Technical Note

Project: Cornbrook

Title: 139133/FO/2024 Highways Consultation Response

Drawing Number
SK22387-001

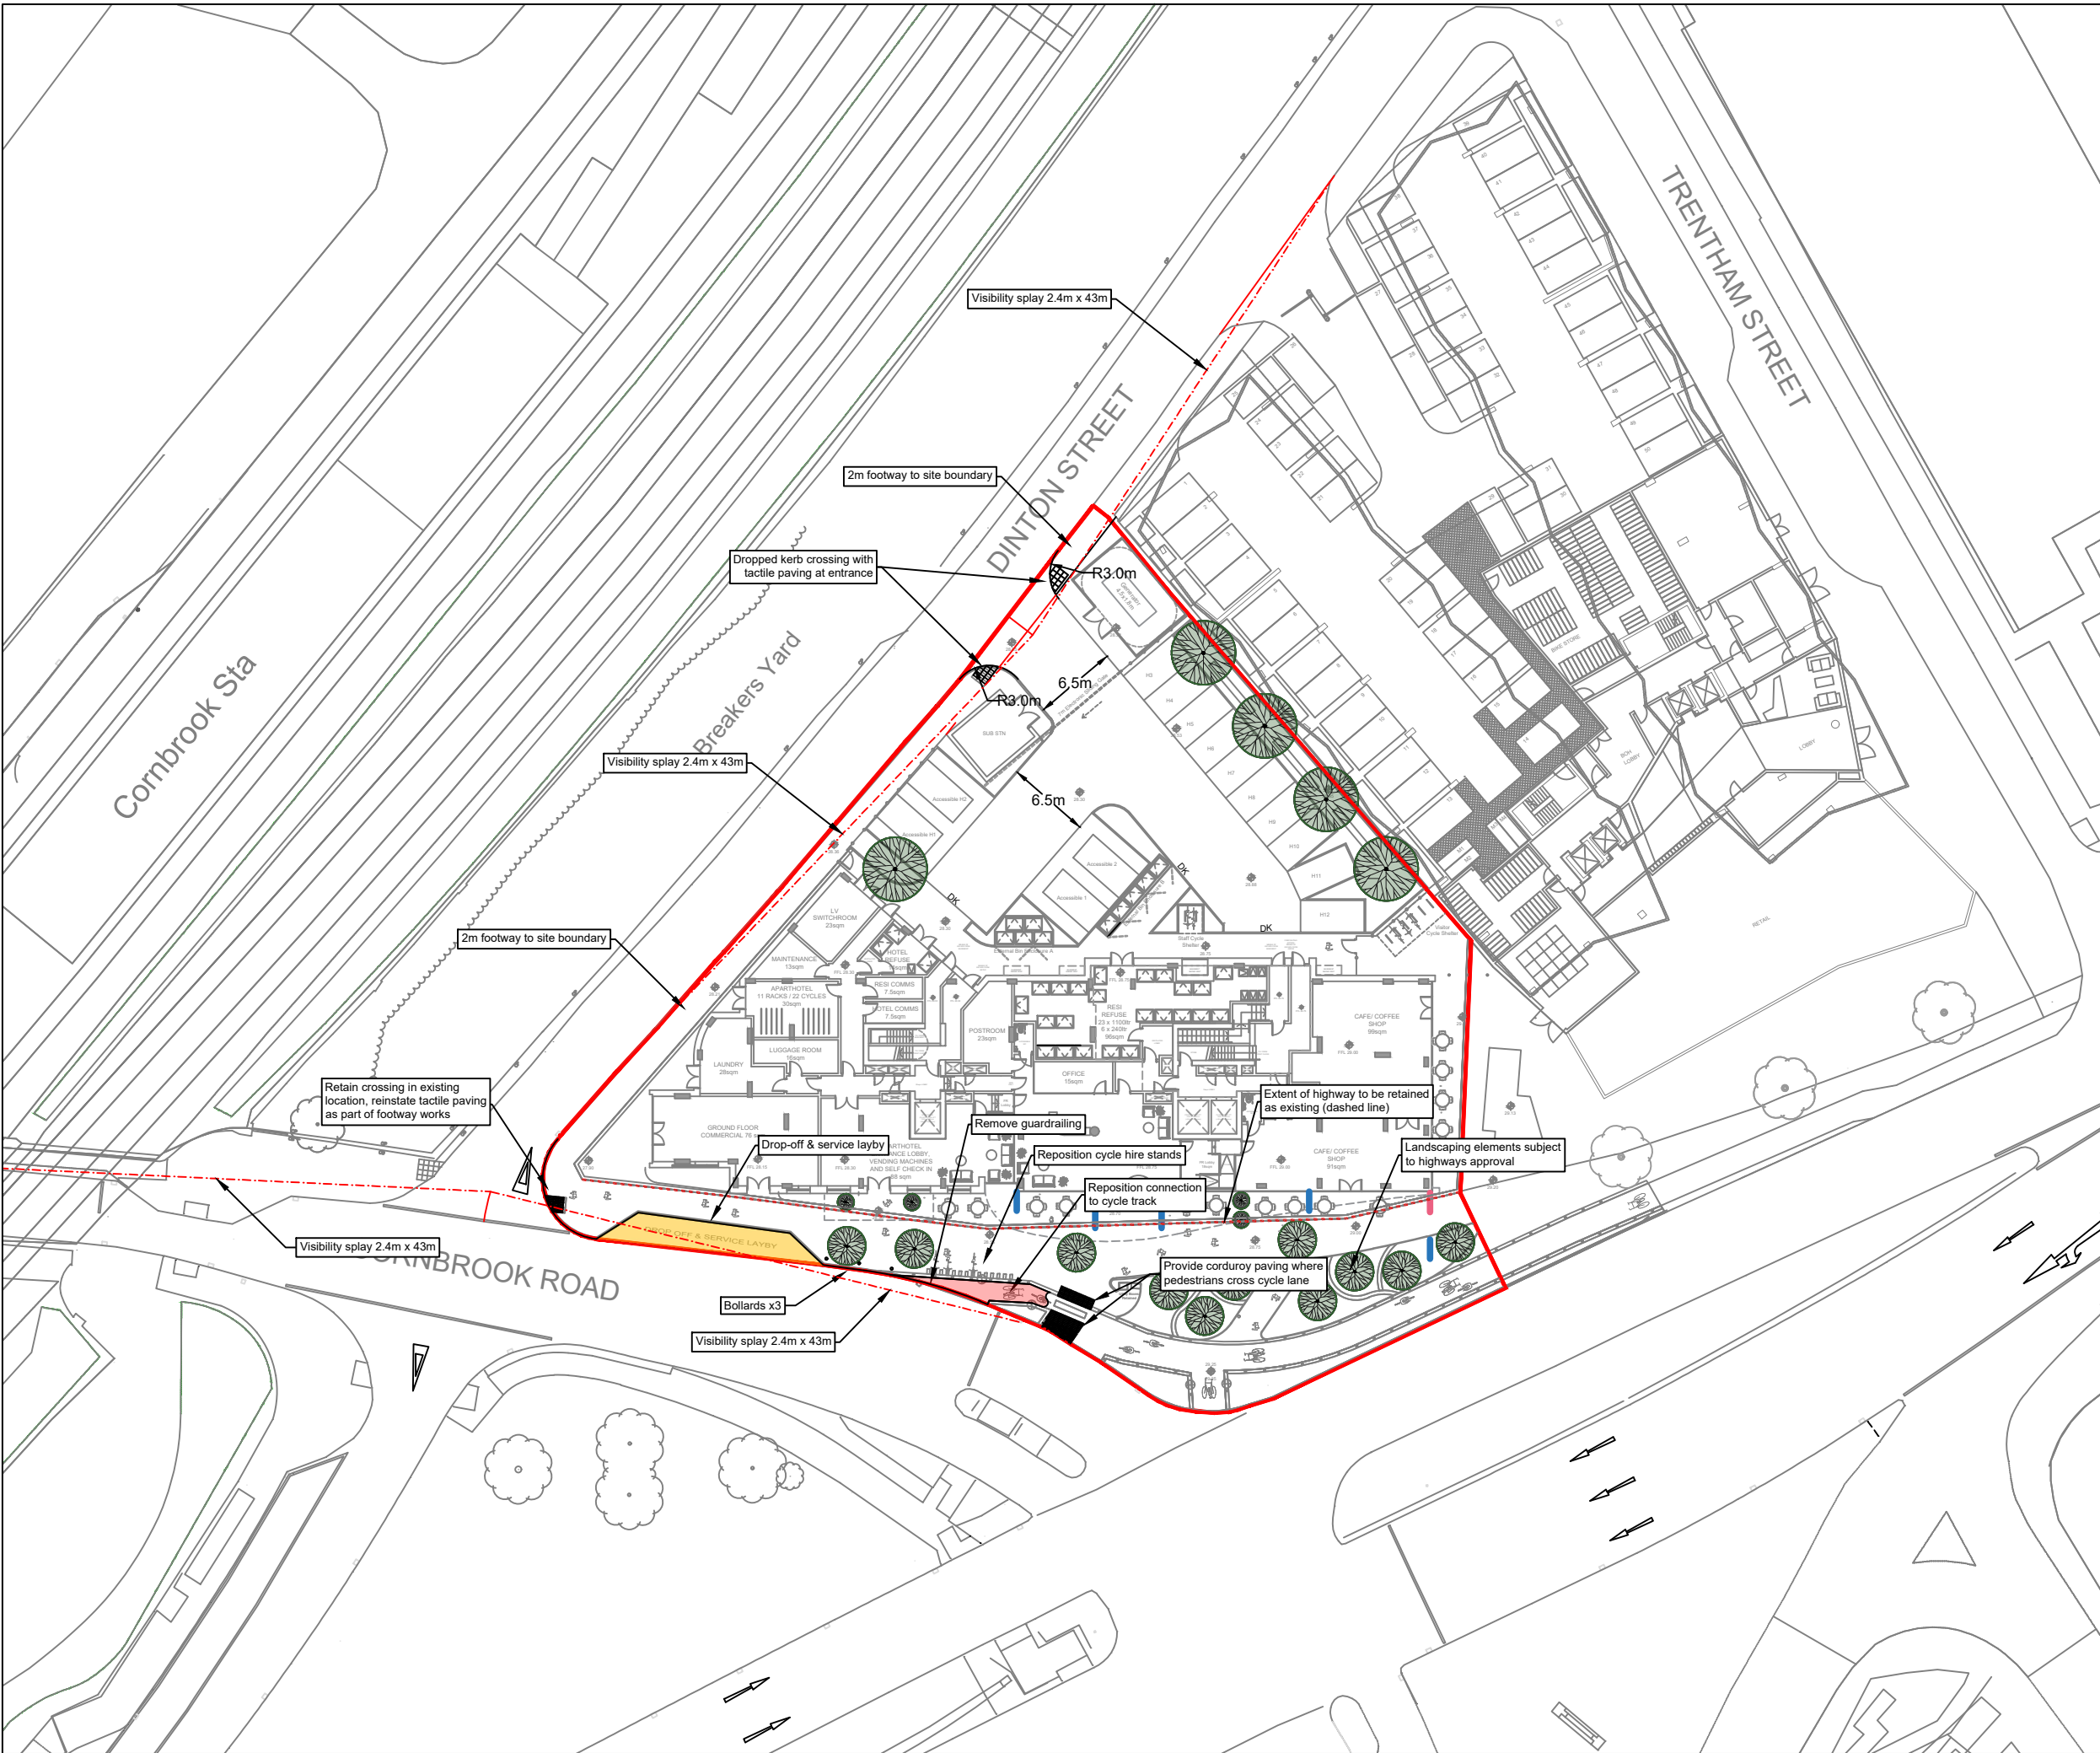
Plans also show public realm works along the site frontage at Cornbrook Road/A56 which would impact on existing Bee Network Cycle hire provision. Such provision would need to be relocated appropriately as part of the proposals with such works funded by the applicant.

As part of the Cornbrook Hub masterplan, a bus/coach lay-by was proposed at Cornbrook Road in the vicinity of the proposed drop-off/service layby associated with the current proposals. It is unclear whether this has been taken into consideration as part of the submission.

Highways request that any redundant site access points are reinstated with full footway provision as part of the works.

Highways request submission of plans showing adequate levels of visibility can be achieved at the Dinton Street site access and at the Dinton Street/Cornbrook Road junction given the proximity of the proposed loading bay.

- 2.5 Proposed repositioning of the Bee Network Cycle Hire facility is included in the updated highway works proposal drawing, as attached.

- 2.10 The layby on Cornbrook Road has been retained at the same dimensions as was proposed as part of the previous scheme which will be suitable for multi-function use including drop-off. As requested during pre-application scoping discussions an RSA Stage 1 has been undertaken in relation to the external highway works proposals and the external works design as submitted with the application reflects the recommendations of the RSA, the RSA itself was included as an appendix to the TA document. The attached updated drawing retains the elements recommended/modified via the RSA process.

- 2.12 Noted, this is covered with the highway works proposals.

- 2.13 As noted above the loading bay position and dimensions are as per the previously accepted scheme. Visibility splays are indicated within the attached layout update.
